Addendum #3 - Bid Package #6929-07

Project Name: Lincoln Public Schools District Office
5901 'O' Street
Lincoln, NE
Project No.: 11065
Issued: August 17, 2012

08/17/12
SHEET
E102
ATTACHMENT NO.
E4
BJF

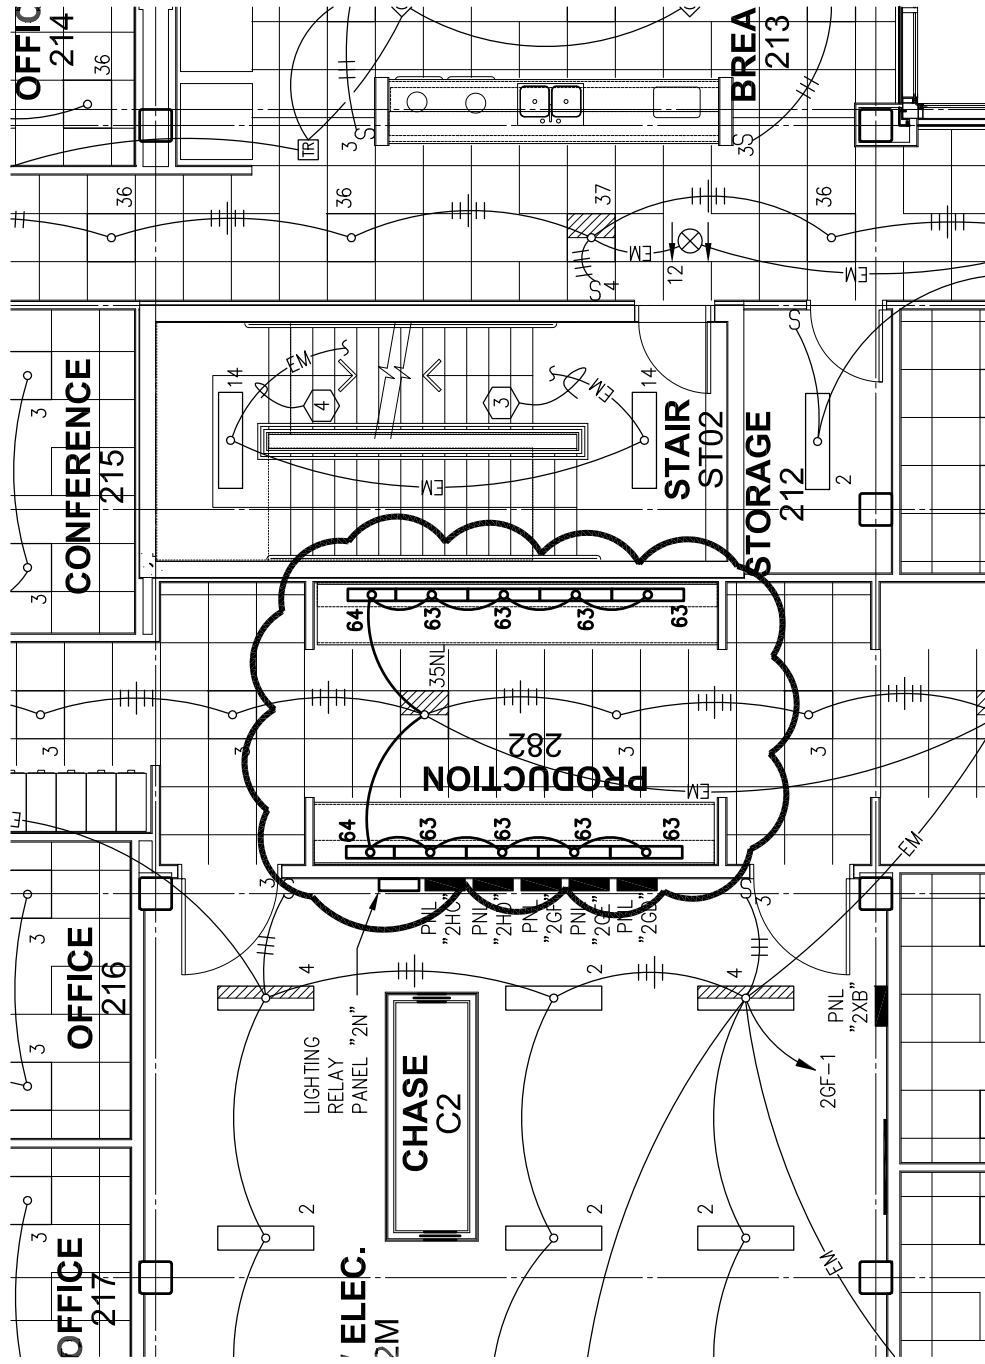
ADD 3-24. Refer to Sheet E102 – Second Floor Plan – Lighting

- A. Change Light Fixture 35NL to Type 3NL, (delete bodine transfer device). Light fixture shall still be connected to emergency circuit and shall be unswitched.
- B. Provide under cabinet lighting as indicated. See **attached drawings E4 and E5.**

08/17/12
SHEET
E103
ATTACHMENT NO.
E6
B.J.F.

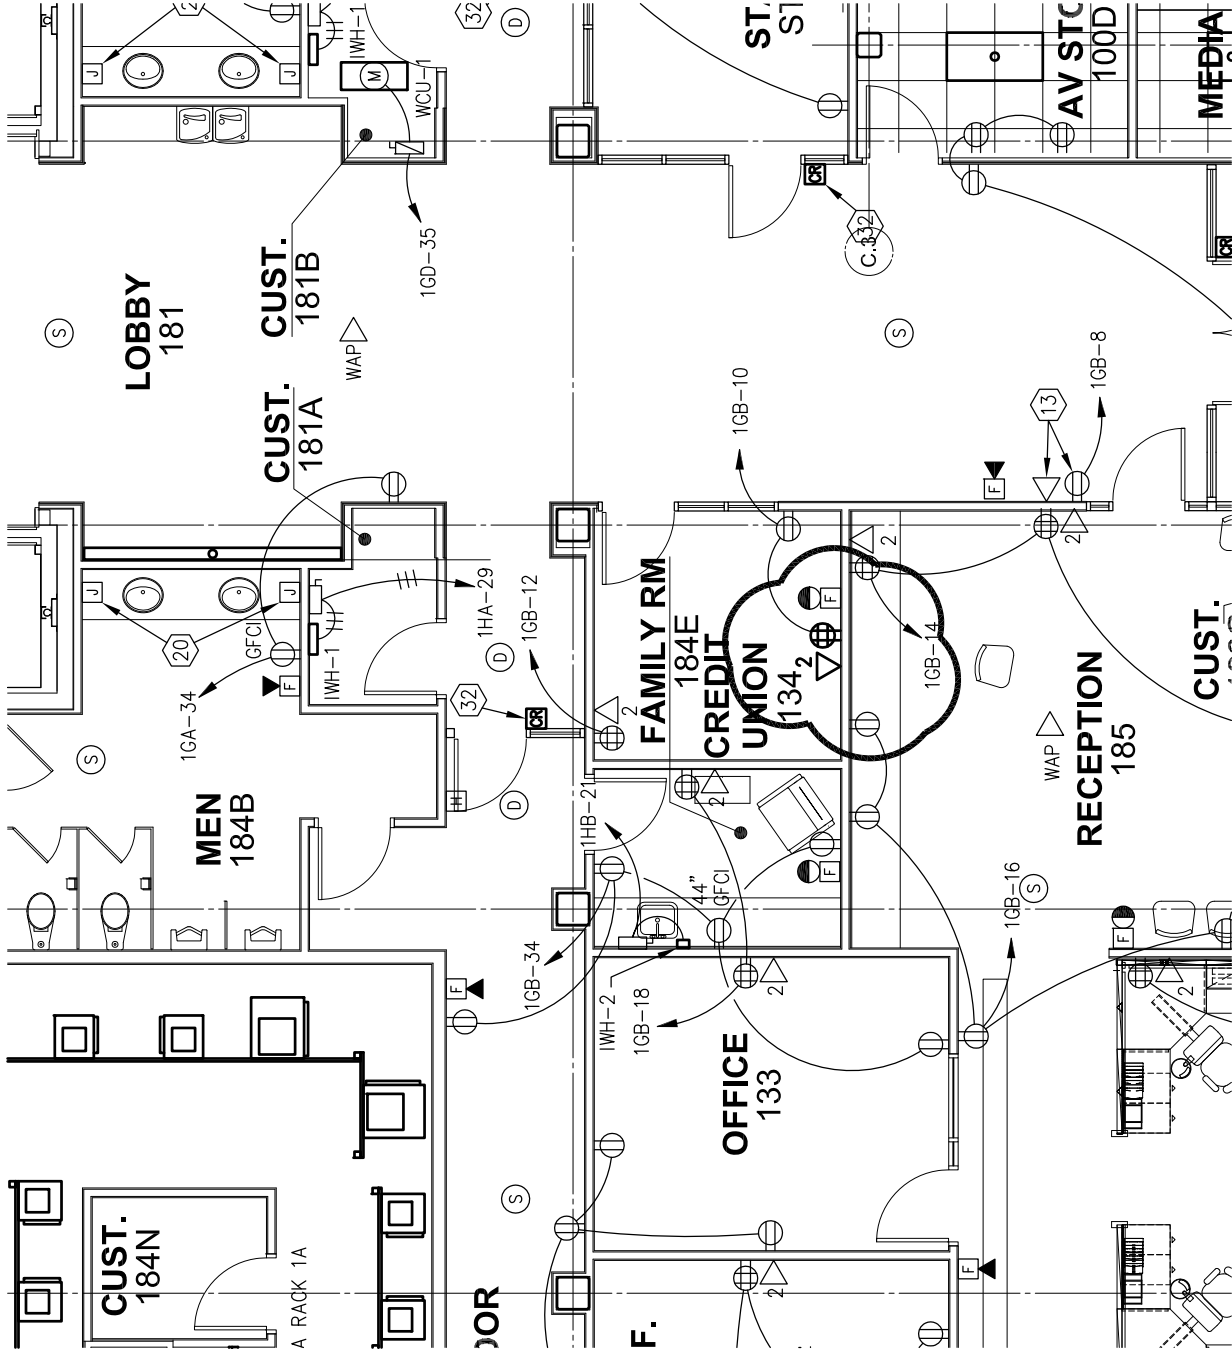
ADD 3-25. Refer to Sheet E103 – Third Floor Plan – Lighting

- A. Change Light Fixture 35NL to Type 3NL, (delete bodine transfer device). Light fixture shall still be connected to emergency circuit and shall be unswitched.
- B. Change Light Fixture 37NL to Type 36NL, (delete bodine transfer device). Light fixture shall still be connected to emergency circuit and shall be unswitched.
- C. Provide under cabinet lighting as indicated and the addition of a Type 3 light fixture. See **attached drawing E6.**
- D. Provide under cabinet lighting as indicated and add circuit number to lighting circuit. See **attached drawing E7.**

08/17/12
SHEET
E201
ATTACHMENT NO.
E8
B.J.F.

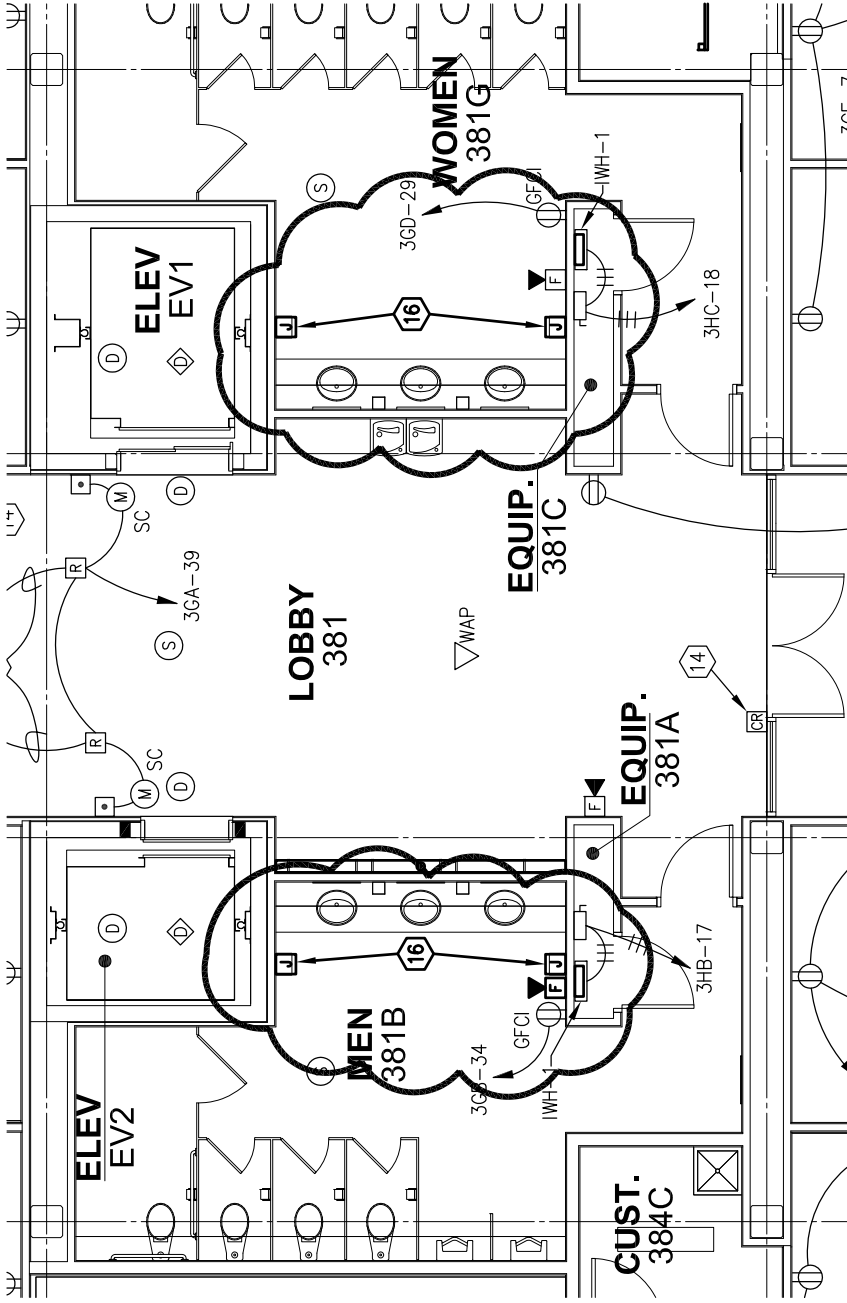
ADD 3-26. Refer to Sheet E201 – First Floor Plan - Electrical

- A. In Vestibule 184A the keyed switch for the handicap door operators shall shutdown all three door operators.
- B. Add data outlet with 2 jacks and change duplex receptacle to four-plex in Credit Union 134. See **attached drawing E8.**
